Origination Form

Proposed Revisions to a Standard Plans Index

Originator:	Stepp, Richard	Index Number:	536-002
Date:	7/25/2024	Sheet Number(s):	1, 27, 28
E-mail:	richard.stepp@dot.state.fl.us	Index Title:	Guardrail Transitions and Connections for Existing Bridges

GUARDRAIL TRAILING END TRANSITION CONNECTIONS FOR EXISTING FLAT SLAB, PRESTRESSED BEAM AND GIRDER BRIDGES WITH SAFETY SHAPE TRAFFIC RAILING EXTENDING LESS THAN FULL APPROACH SLAB LENGTH

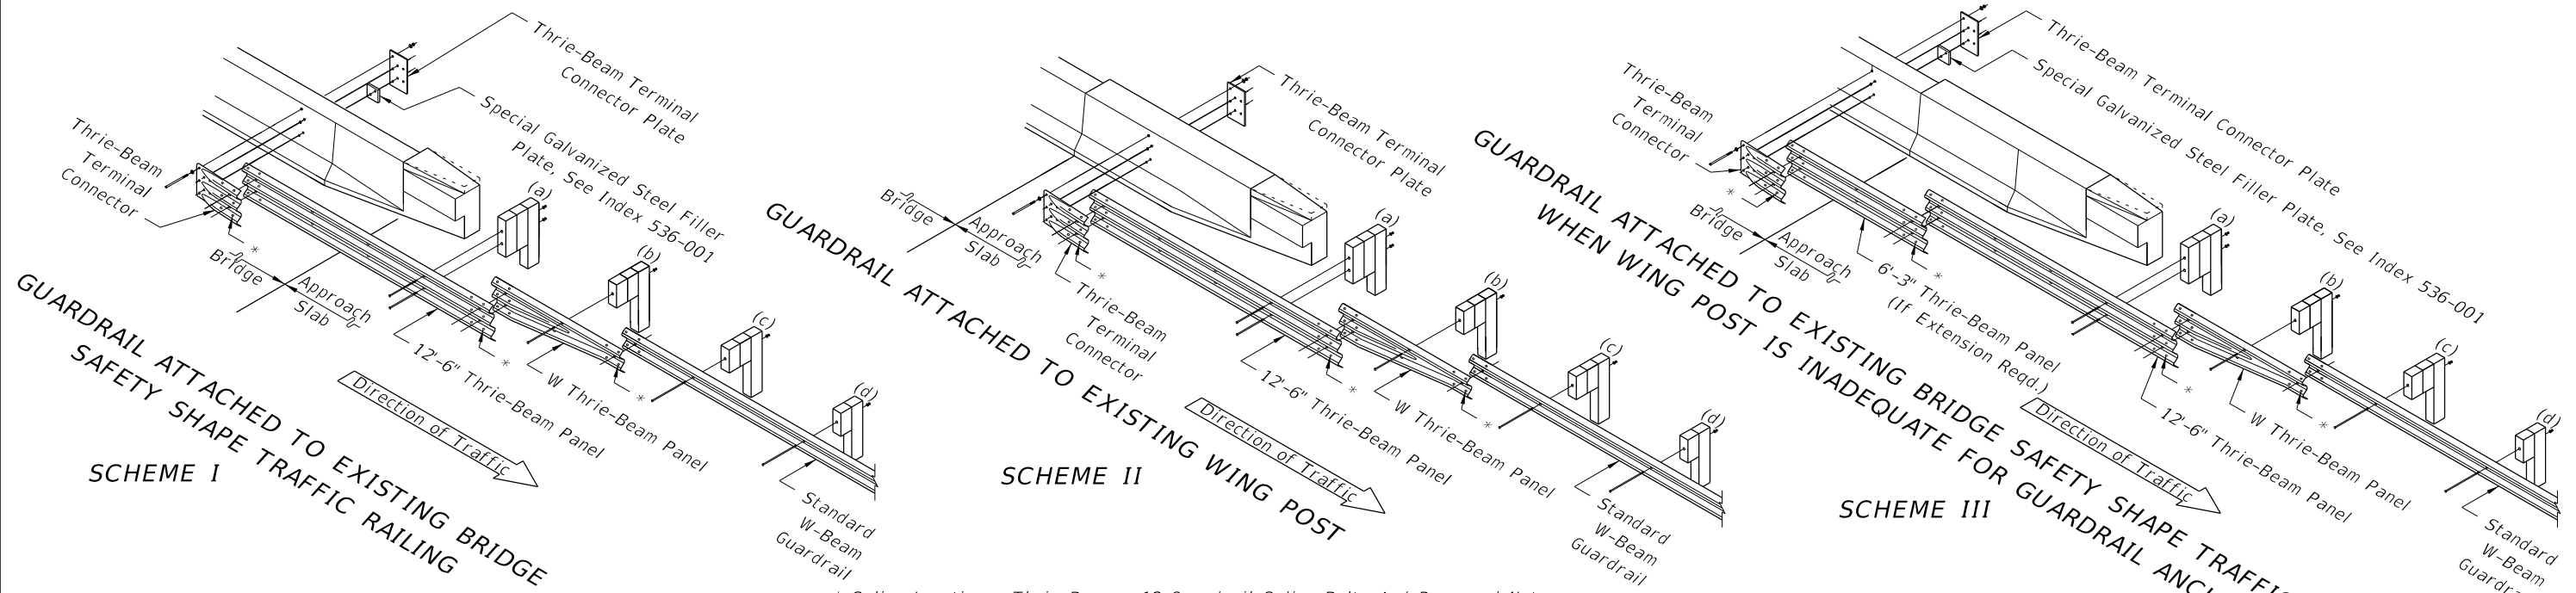
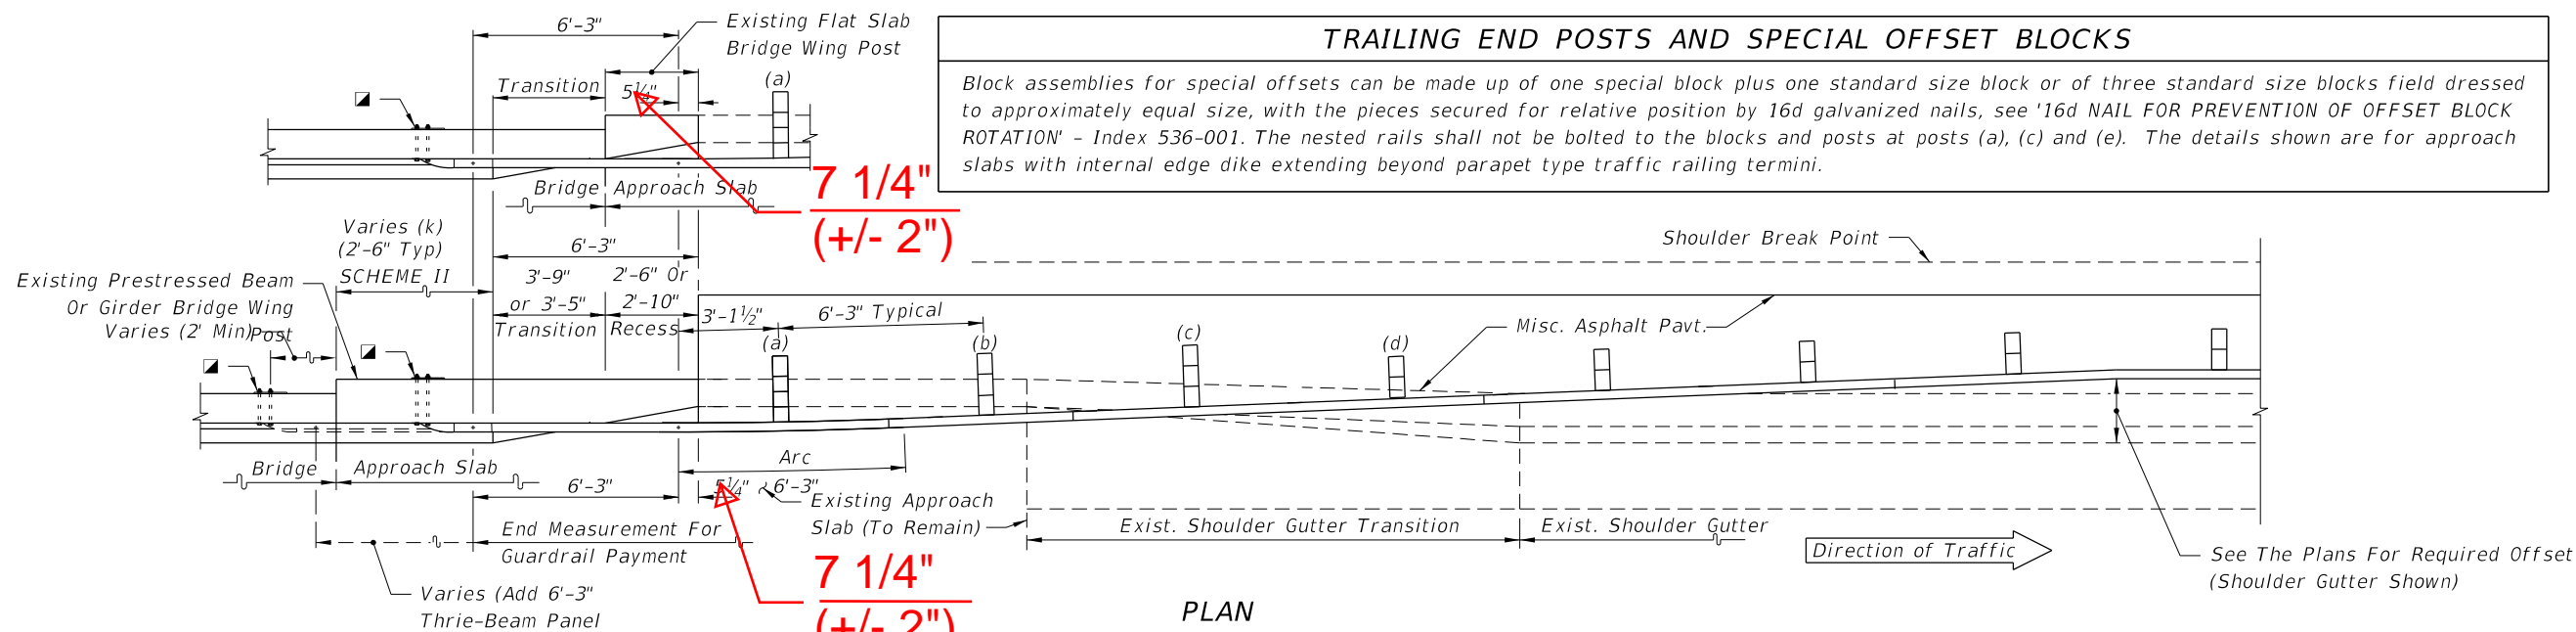
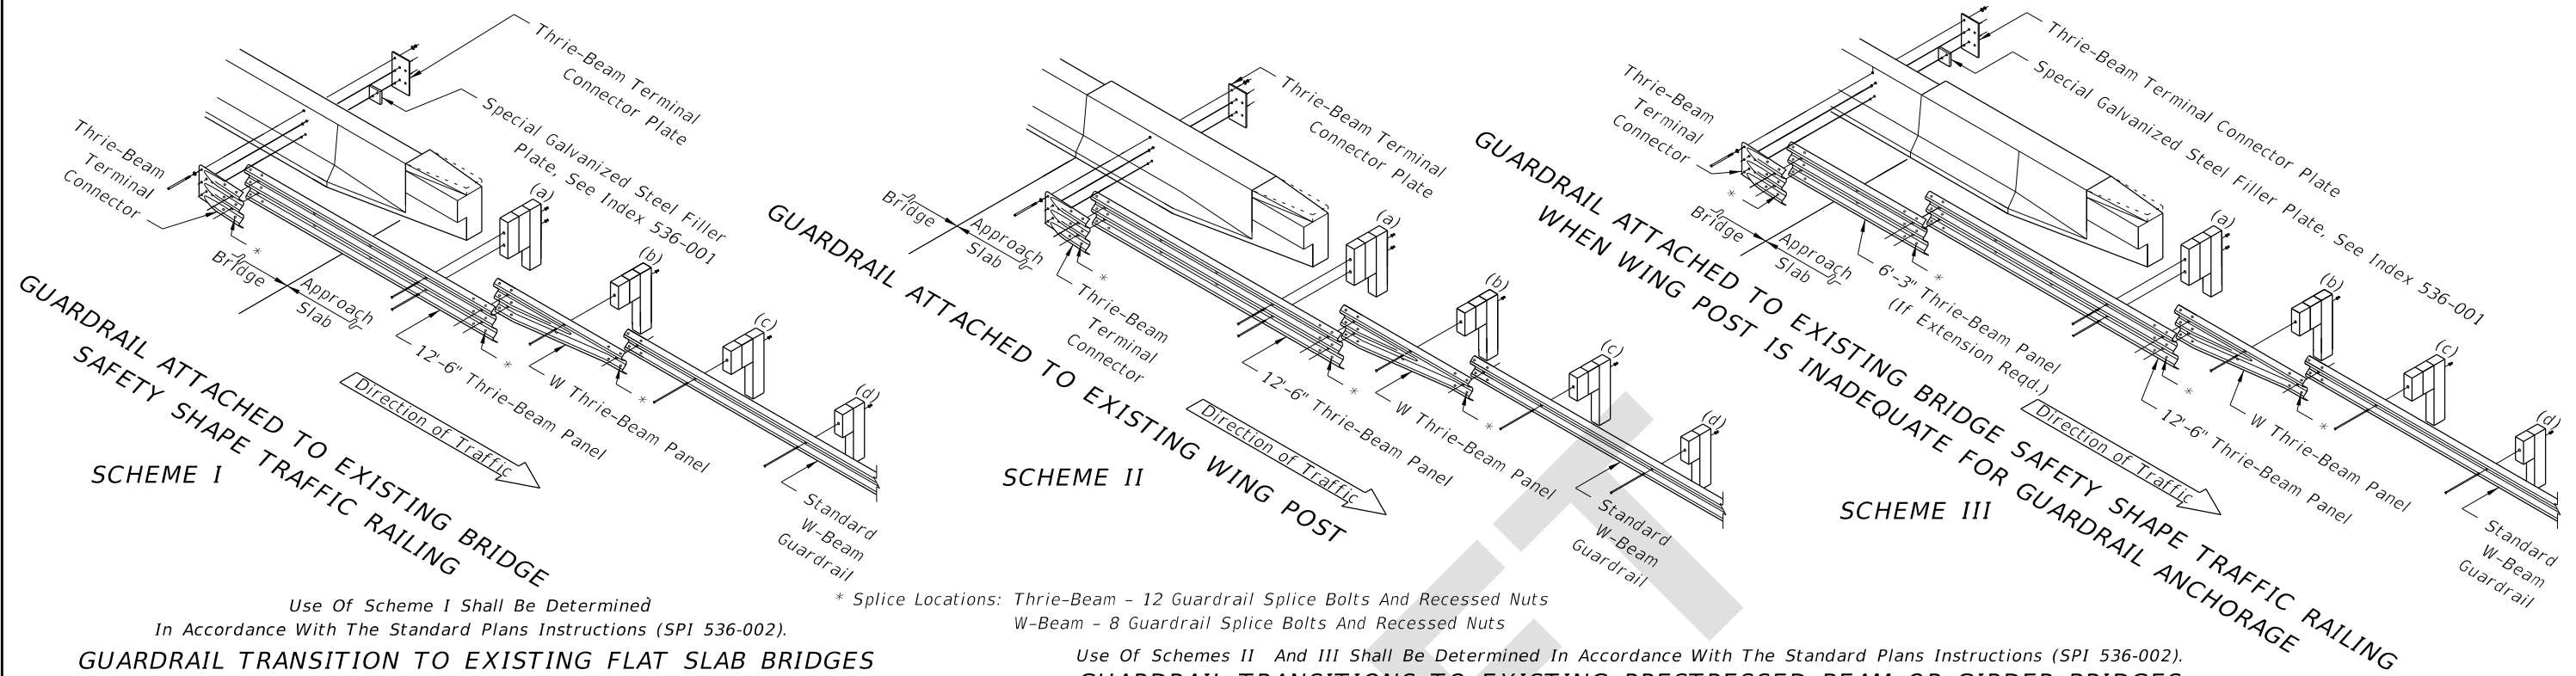
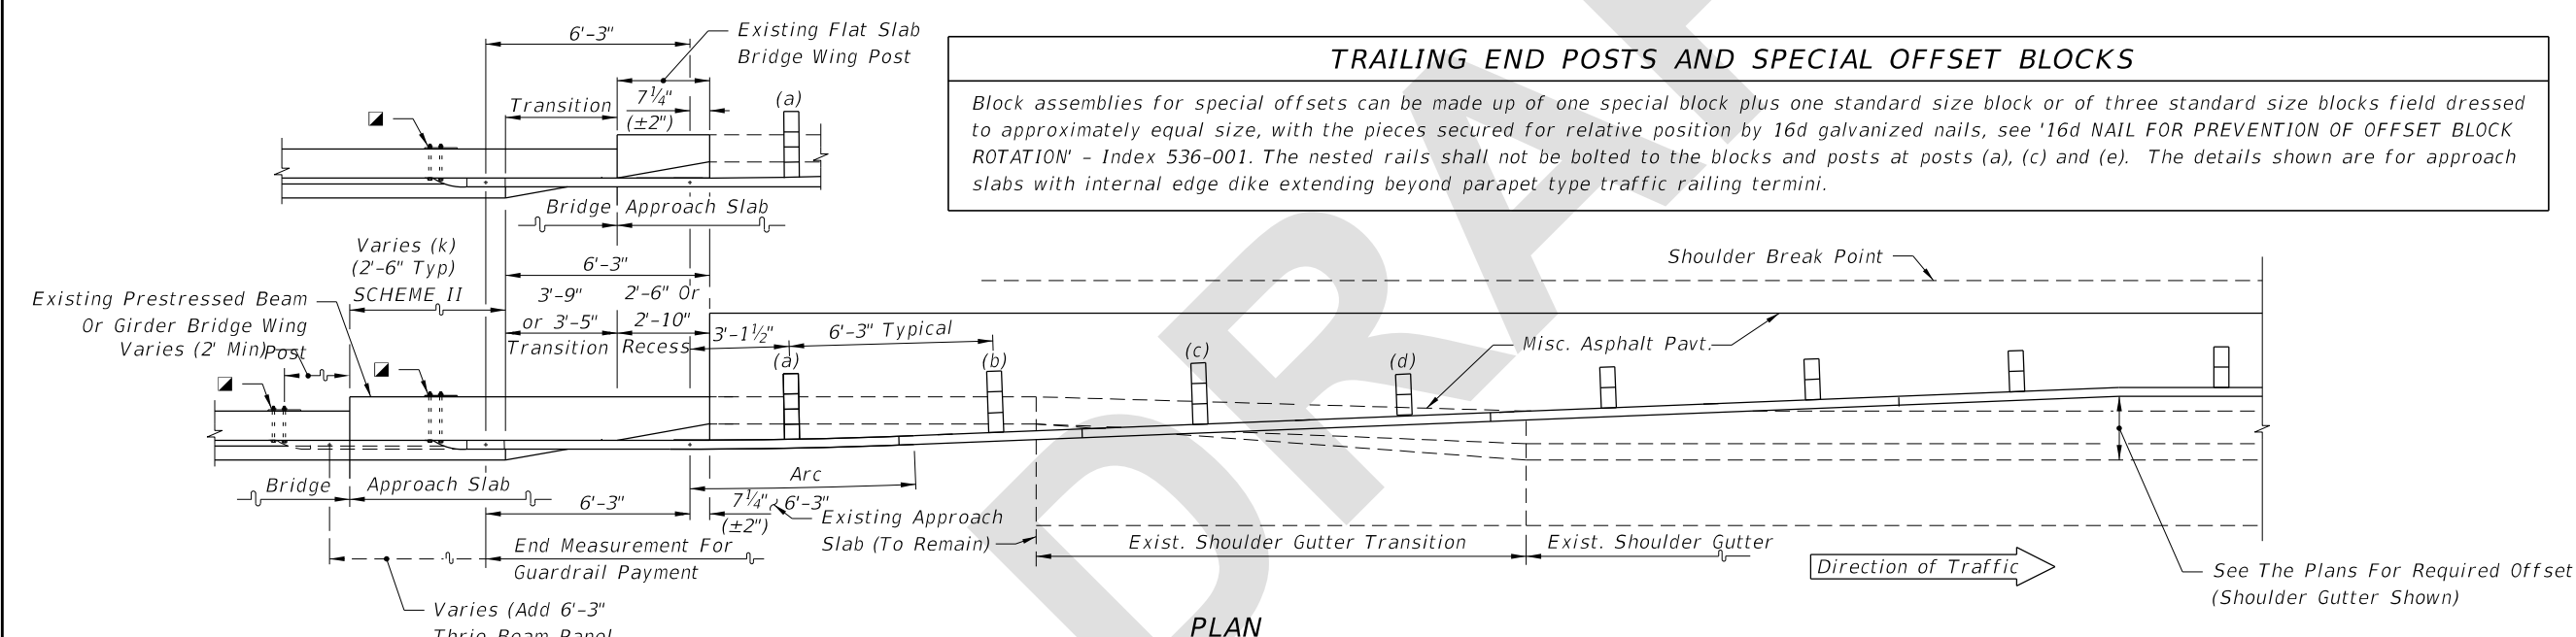
Sheet 1: Added a note explaining required rectangular washer usage to General Note 2.
 Sheet 27: Changed guardrail's longitudinal alignment measurement from the end of concrete from 5 1/4" to 7 1/4" (+/- 2")
 Sheet 28: Changed guardrail's longitudinal alignment measurement from the end of concrete from 5 1/4" to 7 1/4" (+/- 2")

Sheet 1: Contractors questioned if the rectangular washer policy of the referenced Index 536-001 applies, so this added note provides that clarification.
 Sheets 27 & 28: Changed longitudinal dimension to align with crash-tested systems and provide a broader tolerance for placement that follows successful practices in other states.
